**MONITORED NATURAL AND ENHANCED ATTENUATION OF THE  
ALLUVIAL AQUIFER AND SUBPILE SOILS AT THE MONUMENT VALLEY,  
ARIZONA, PROCESSING SITE: REVIEW OF FINAL STUDY REPORT**

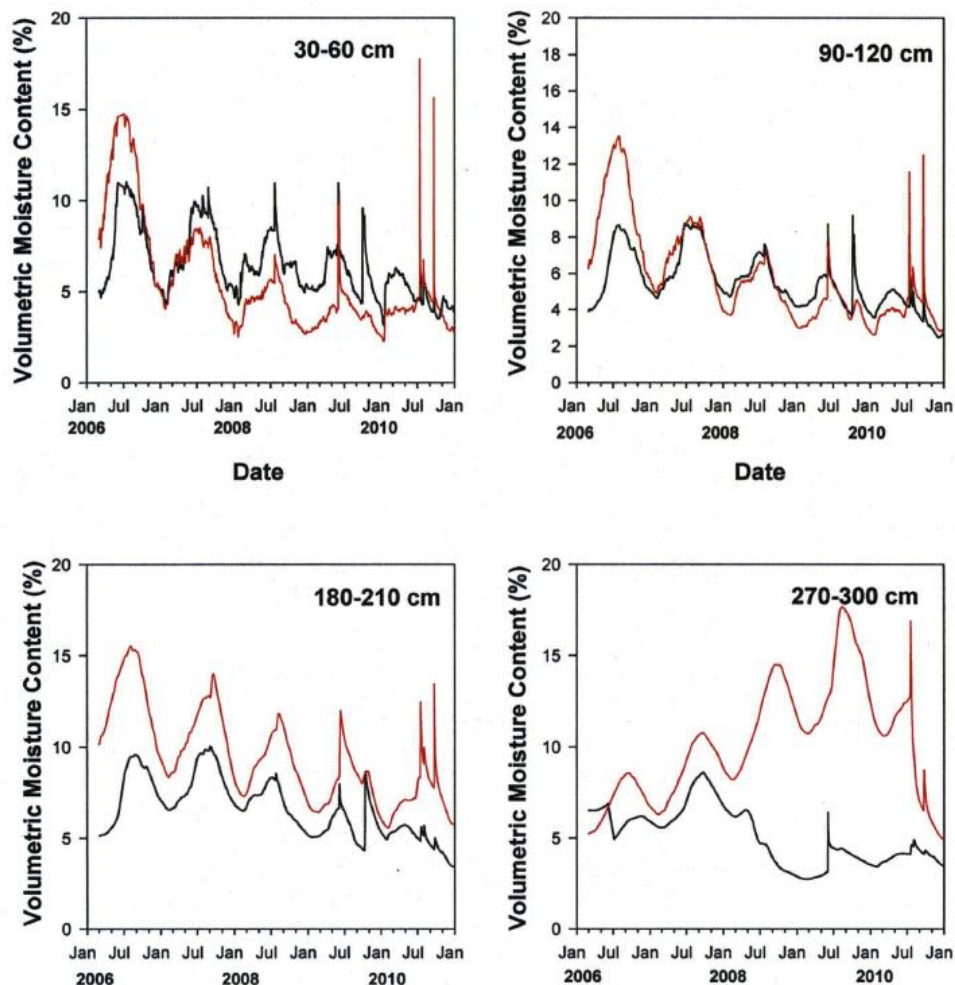
Questions remain regarding the conclusion by DOE of no downward water movement in the subpile soils including: (i) the water content deeper in the subpile soils for the Old Field appears to have an increasing trend, which may potentially result in downward water movement, especially if the trend continues; and (ii) only 4 water flux meters were used for the 3.3 ha [8.2 ac] of planted fields where enhanced phytoremediation was tested. For the former concern, Figure 3-1 shows an increasing trend of the soil water content at the 270–300 cm [106–118 inches (in)] depth. During the growing season of 2009 and 2010, it appears as if the volumetric water content exceeded the field capacity of  $0.15 \text{ cm}^3/\text{cm}^3$  [15 percent] (Pilot Study Report, p. B–25). It is not clear why this increasing trend is only found in the Old Field. In a Groundwater Compliance Action Plan, DOE will need to give more detail on how irrigation will be managed to prevent an increase in water content deeper in the soil profile as shown in Figure 3-1. For the latter concern, data based on only 4 water flux meters for 3.3 ha [8.3 ac] may be insufficient to draw conclusions for all of the area. Only a single water flux meter was used on the Old Field. Because soils have heterogeneities in their structure, as do most natural porous media, downward water flux may be occurring at locations other than where the water flux meters are positioned.

In addition, DOE needs to provide further evidence that there is no downward water migration. Other than measurements of water content, there was only a single water flux meter in a 1.7-ha [4.2-ac] field (the Old Field). A single water flux meter is not sufficient to conclude that there is no downward water movement from subpile soils toward the alluvial aquifer. Further, DOE should explain why the water content at the 270–300 cm [106–118 in] depth appears to have an increasing trend, which may indicate downward water movement.

**Figure 3-2. Initial Concentrations of Nitrate and Ammonium in the Old Field, 200, and the Amount of Nitrate and Ammonium Removed by 2010, As a Function of Soil Depth (Reproduced From the Pilot Study Report, Appendix B, Figure B-27).**

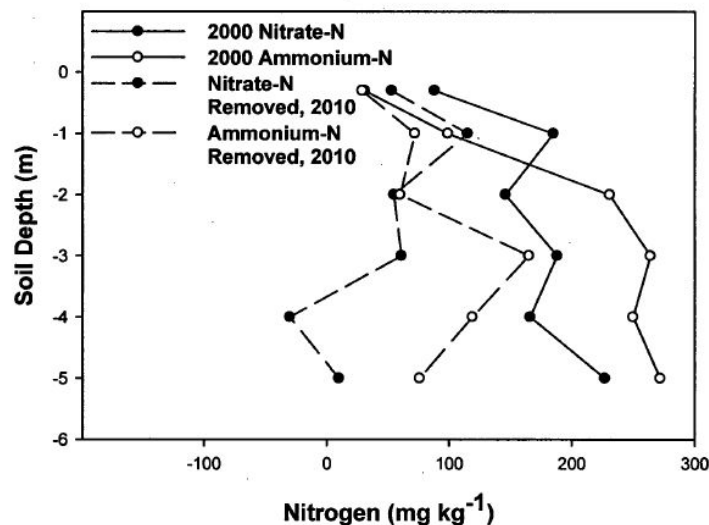
In addition, DOE needs to resolve the apparent contradiction between Tables 3-1 and 3-2 and Figure 3-2. In the tables, more nitrate appears to have been removed than ammonium. In the figure, more ammonium appears to have been reduced than nitrate. The increase in nitrate deeper in the subpile soil between 2004 and 2010 also needs to be clearly explained.

Figure 3-3. Distribution of Nitrate, Ammonium, and Sulfate as a Function of Soil Depth in Source Area Soil Samples From the Old Field in 2010 (Modified From the Pilot Study Report, Appendix B, Figure B–26)

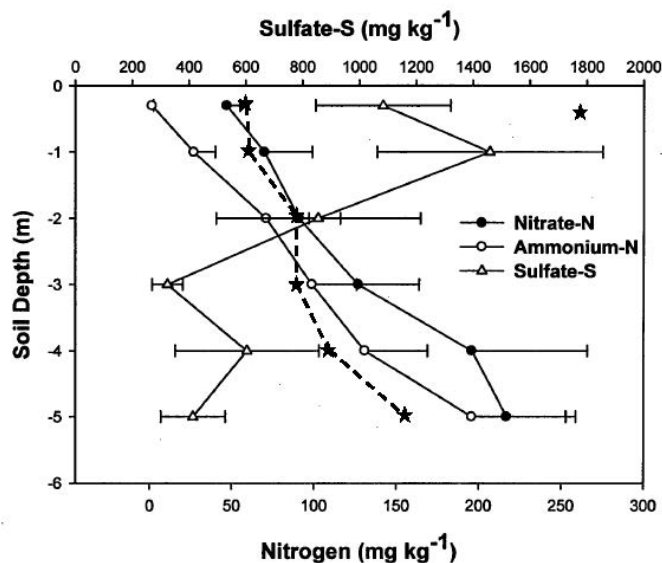
In Figure 3-3, DOE shows that the sulfate concentration in the subpile soils increased because the irrigation source contained sulfate. DOE did not address directly how this increase may affect the subpile soils and potential remediation activities over a long time period. The consequence of adding sulfate to the subpile soils, especially if long-term irrigation is proposed, will need to be investigated.

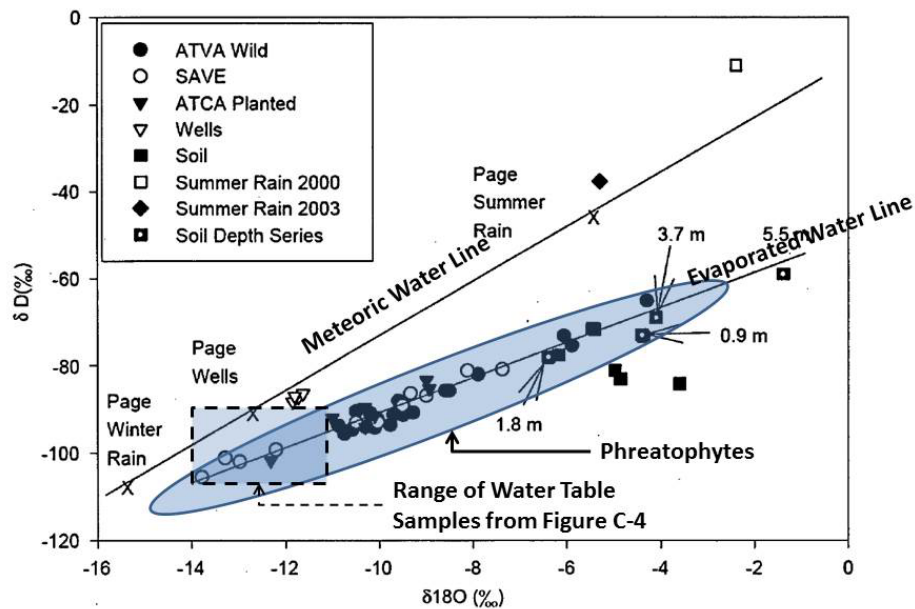
that the phreatophytes are directly transpiring water from the shallow aquifer. Figure 3-5 shows the correlation of enrichment of Hydrogen-2 ( $\delta D$ ) versus Oxygen-18 ( $\delta^{18}O$ ) in groundwater, phreatophyte stem moisture, and the vadose zone water. The phreatophyte stem moisture isotopic ratios all fall on the evaporated water line, as do the soil water ratios, indicating the stem water could be derived either from the vadose zone or locally recharged water.

**Figure 3-6. Correlation Between Reported Annual Evapotranspiration (ET) and Annual Precipitation for Protected Phreatophytes (Plants Inside Fence) and Unprotected Phreatophytes (Outside Fence)**

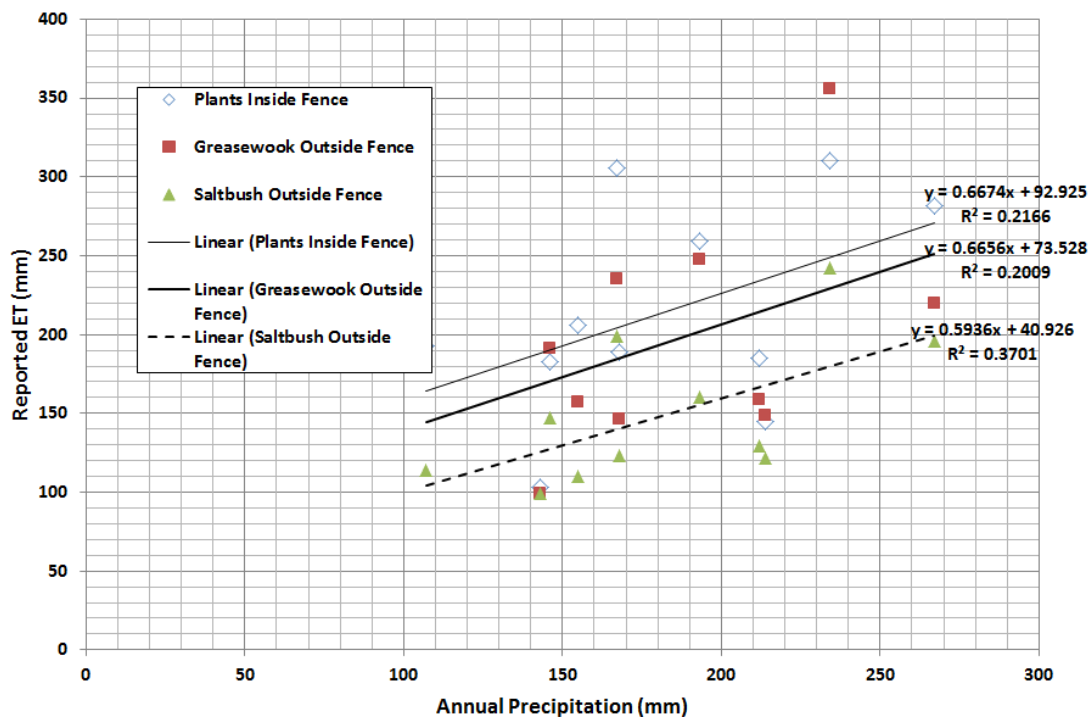
Second, the evapotranspiration rates measured for both protected and unprotected stands of saltbush and black greasewood increase with annual precipitation, as illustrated in Figure 3-6. This suggests that the phreatophytes may be primarily removing infiltrating water before it recharges that aquifer. If the phreatophytes are primarily removing water from the saturated zone the evapotranspiration rates would not vary with annual precipitation. (Note: according to DOE, the water flux meters measured no downward water flux.)
